Service Bulletin

S.B. No: 173

Title: CANOPY LATCH ASSEMBLY COVERS

Applicability: Post Mod M129 T67C, T67M, T67M-MkII, T67M200, T67M260 and T67M260-T3A

FIGURE 1 CANOPY LATCH SET-UP

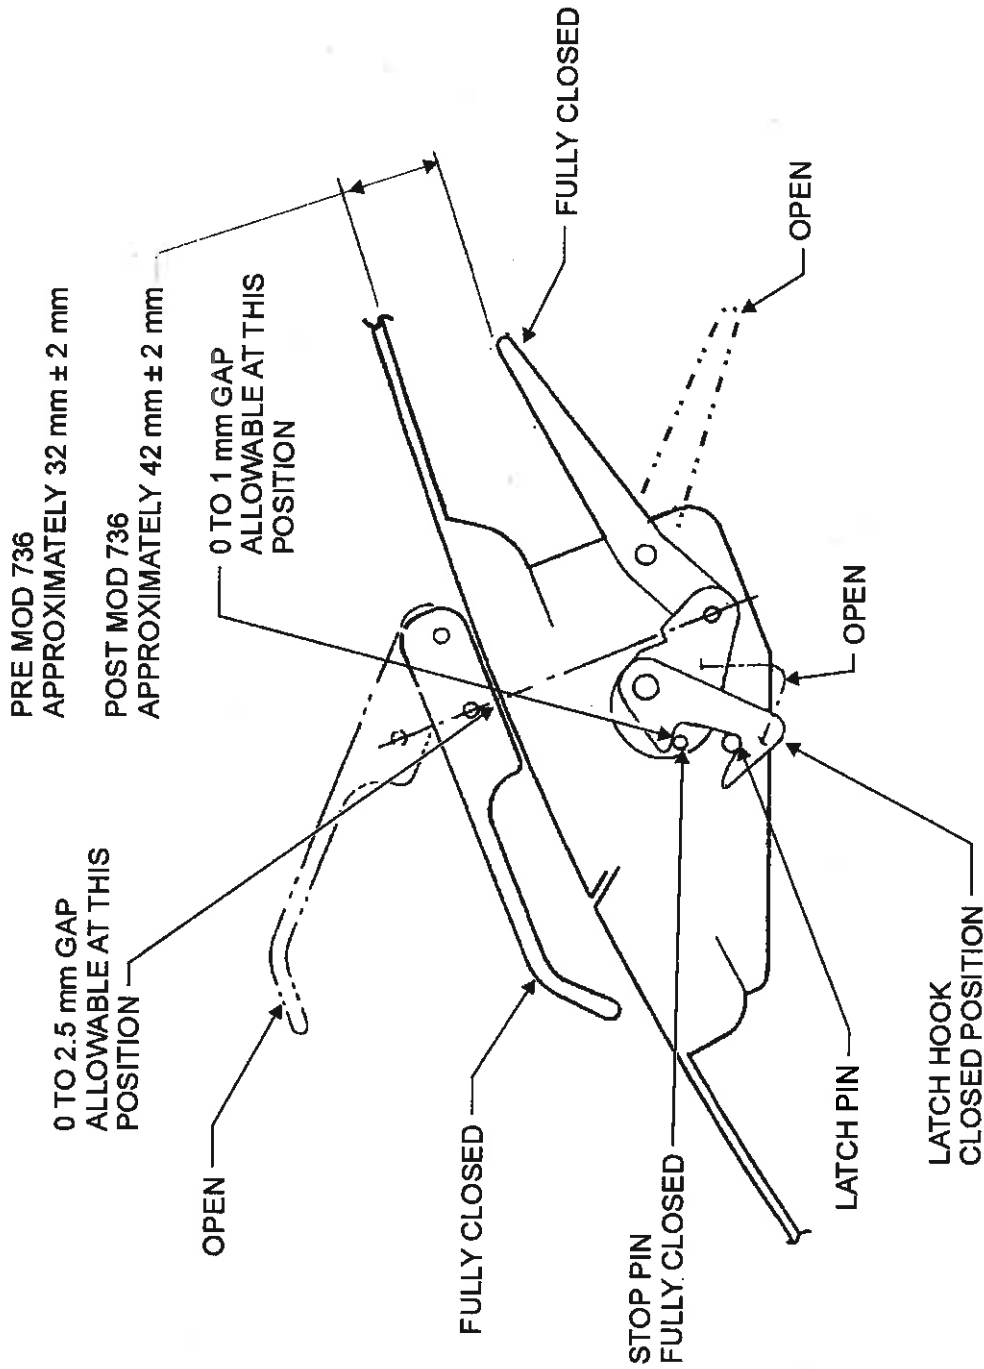
A recommendation has been put forward which improves the ease of visual inspection when checking for correct engagement of the latch hooks with the latch pin. The correct position of the latch hooks and pin for a correctly closed and locked canopy is shown in Figure No.1.

FIGURE 2 LATCH BLOCK COVER ON FIXED CANOPY

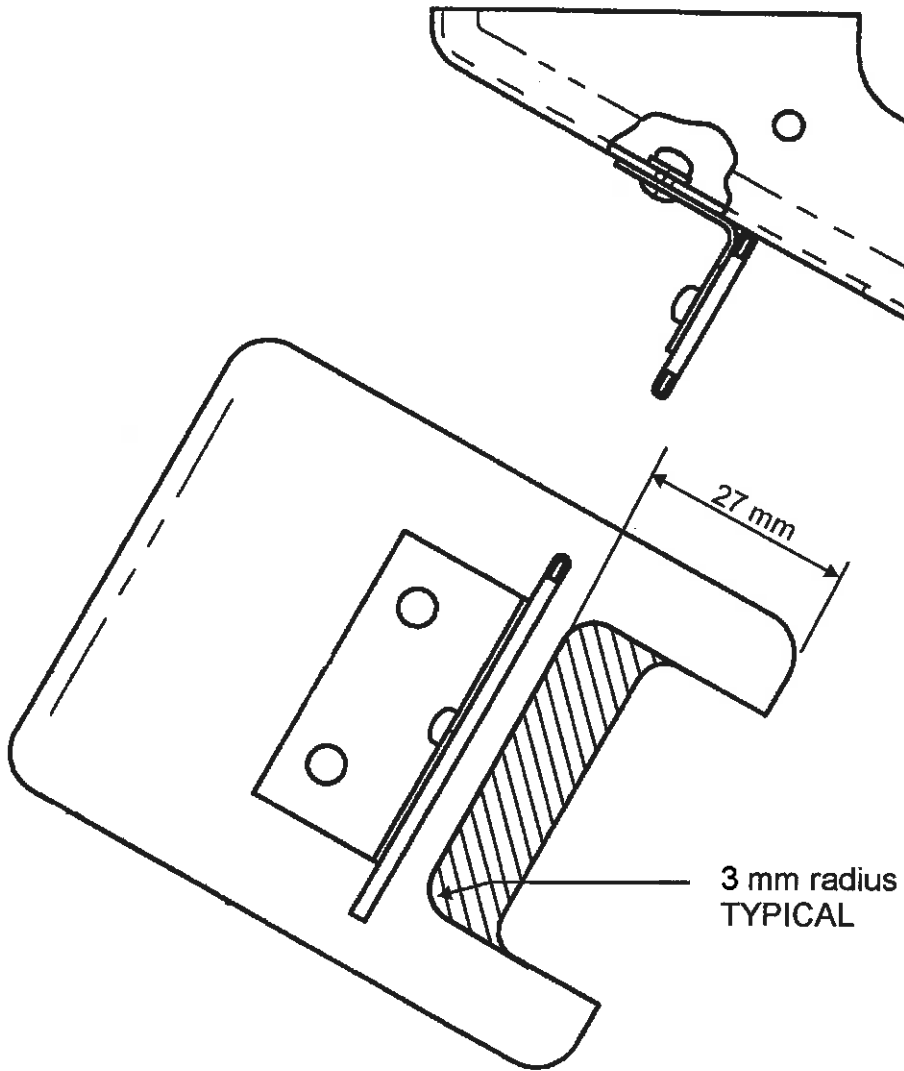
1. Remove the two covers, referenced above, from the aircraft.
2. Carefully cut away the material shown shaded in Figures 2 and 3.

3. Apply epoxy eggshell black paint to the cut edges. Alternatively a black marker pen may be used.
4. Re-identify the covers as follows:
 - i. T67M-17-419 becomes T67M-17-427
 - ii.
 - a. T67M-17-425 (Pre-Mod M755) becomes T67M-17-813
 - b. T67G-17-111 (Post Mod M755) becomes T67G-17-113
5. Re-assemble the covers to the aircraft.
6. Check full and free operation of the canopy latch assembly.
7. Annotate logbook "SB 173 Complied with" and "Modification M944 incorporated".
